HISTORIC PRESERVATION COMMISSION MEETING

CITY OF DAVENPORT, IOWA

TUESDAY, JANUARY 10, 2023; 5:00 PM

- A. Case COA23-01: Request for exterior alteration at 624 West 5th Street. The Charles and Amelia (Ruch) McElroy House is located within the Hamburg Local Landmark Historic District. Duane Timm, petitioner. [Ward 3]

PARTIAL EAST ELEVATION
PARTIAL WEST ELEVATION OPPOSITE HAND
SCALE: 1/4"=1'-0"

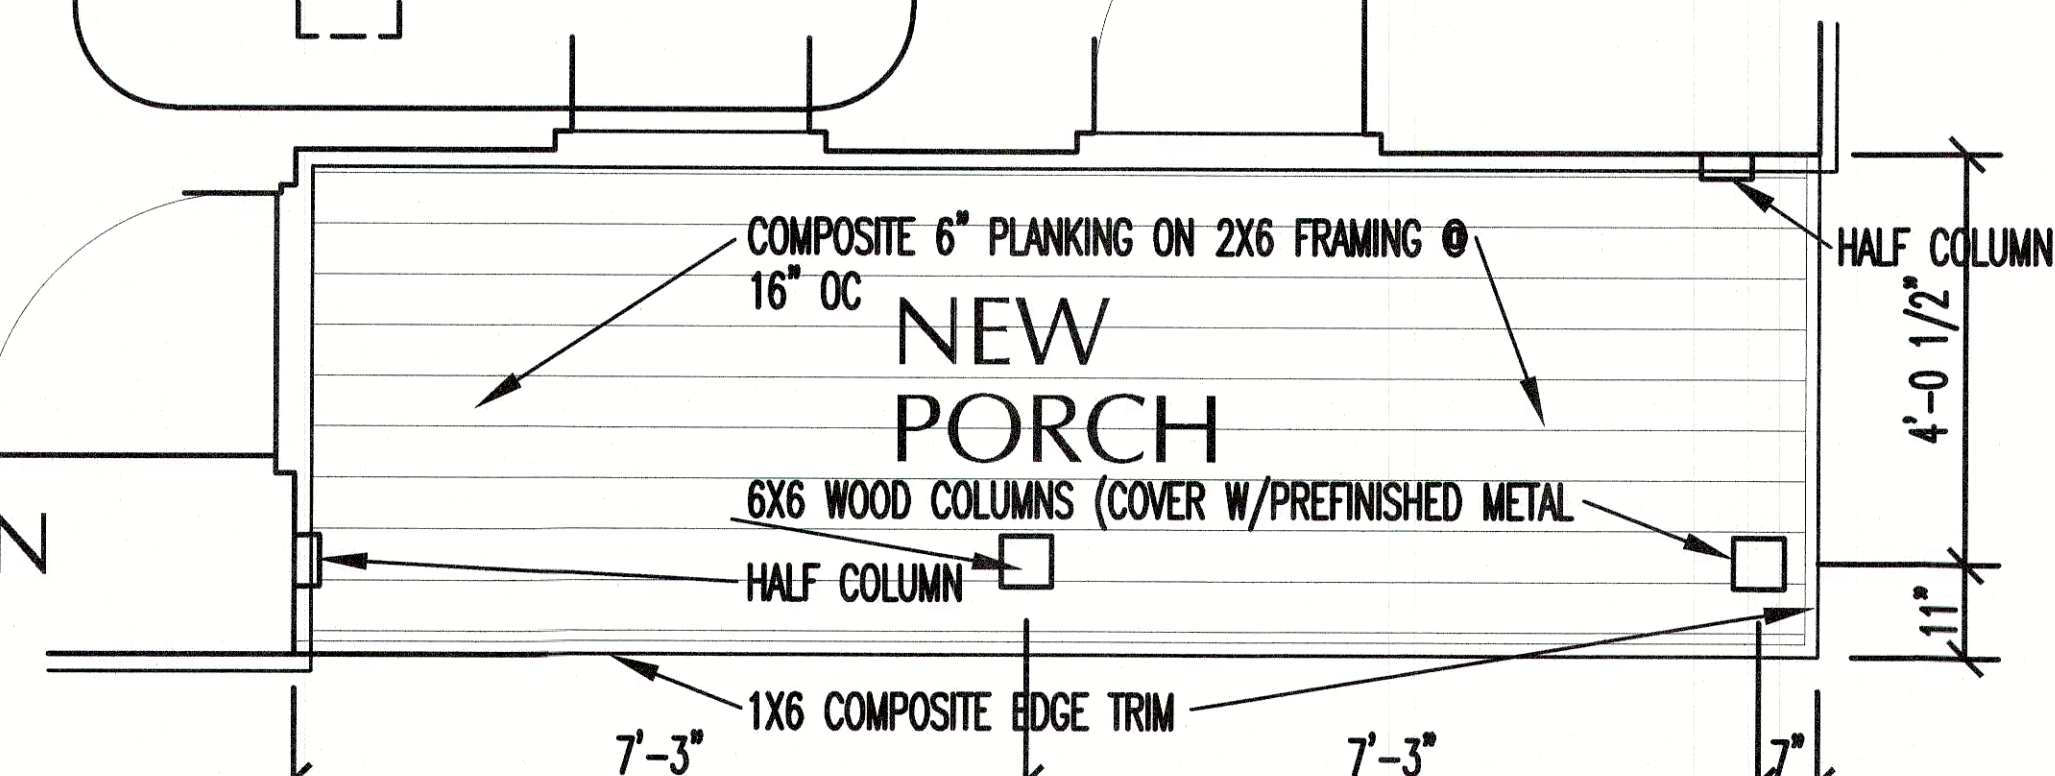
The property inventory sheet identifies the architectural style of the home as "Vernacular Greek Revival". The proposed wood porch brackets appear to be more of an Italianate or Queen Anne architectural style. A simpler bracket or column capital, which extends to the roofline, may be more fitting with a Vernacular Greek Revival style. However, given the location on the east and north elevation, the design will not significantly detract from the historic character of the Hamburg Historic District.

Dr. Gustav Hoepfner House & Office

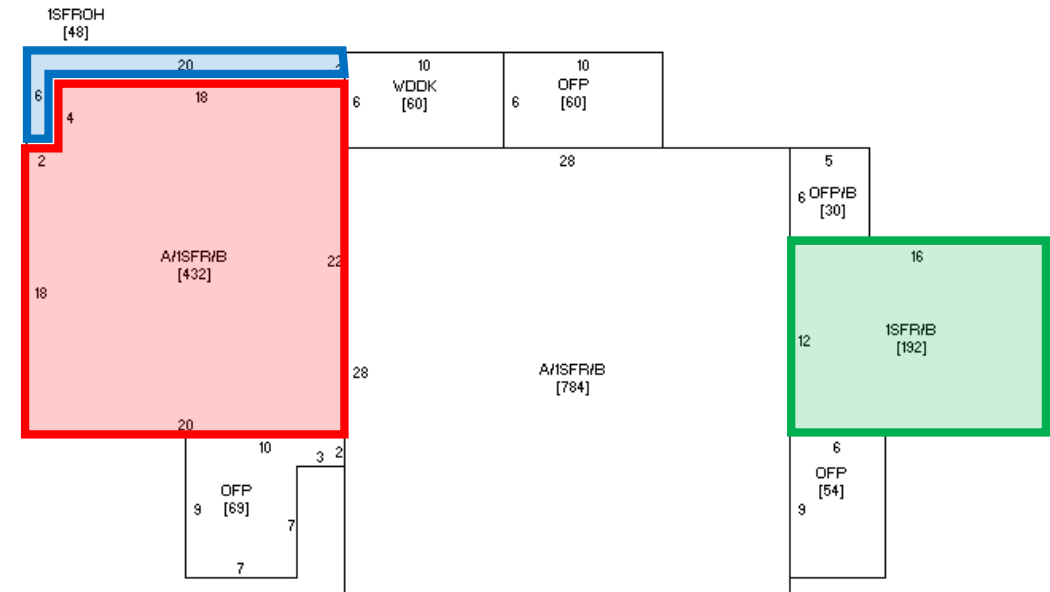
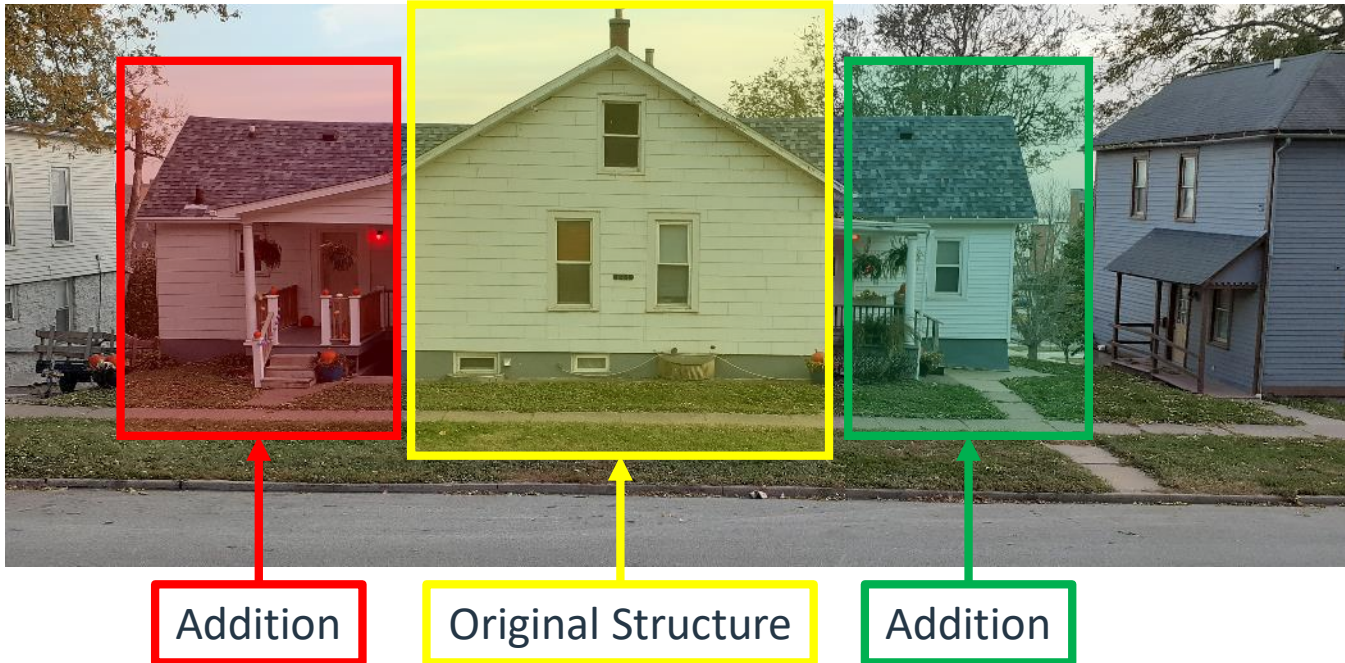
- Since there have been several additions to the home, there is a mismatch of wood, vinyl, and asbestos siding. The applicant is proposing to replace the deteriorated wood siding around the basement door with vinyl. The total wall spans approximately four feet in width, with the door covering a majority of the area. An engineered wood siding may be a more appropriate material given the scope of the project.
